OS-IN-2019-042

**Optimization of Carrier Tape and
Harmonisation of Datasheet
for Lx T66G (x=B,T)
Customer information package**

OS QM CQM ICI | 2020-02-15

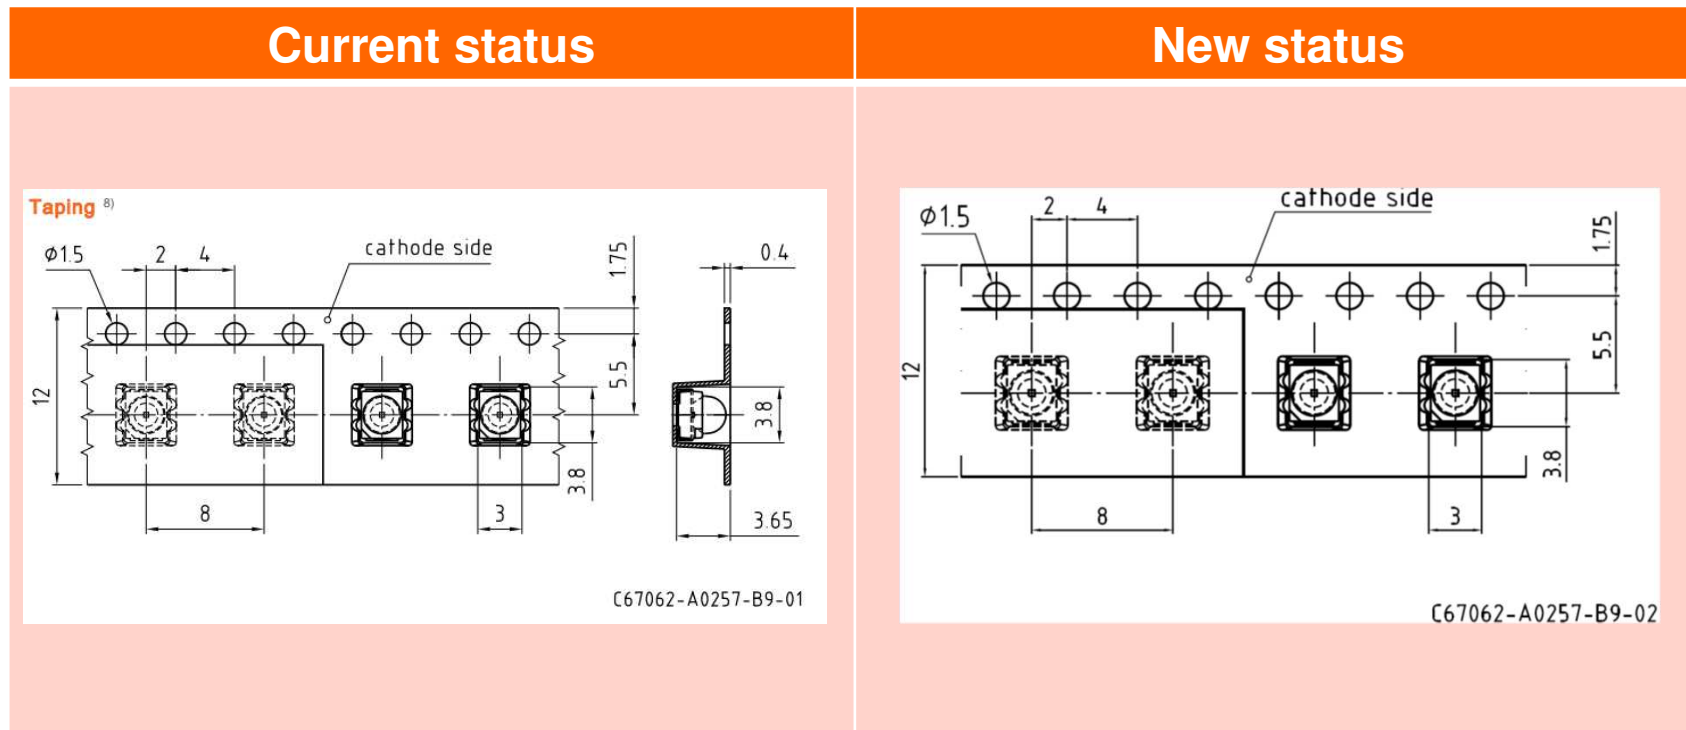
The pocket depth will be reduced from 3,30mm to 3,15mm to reflect the change of the LED height, which was introduced with OS-PCN-2018-030-A.

Note: In current datasheet the pocket depth is stated as 3,65mm, which is a typo error.

For harmonisation of the datasheets of TOPLED Black family the pocket depth will be removed from the drawings.
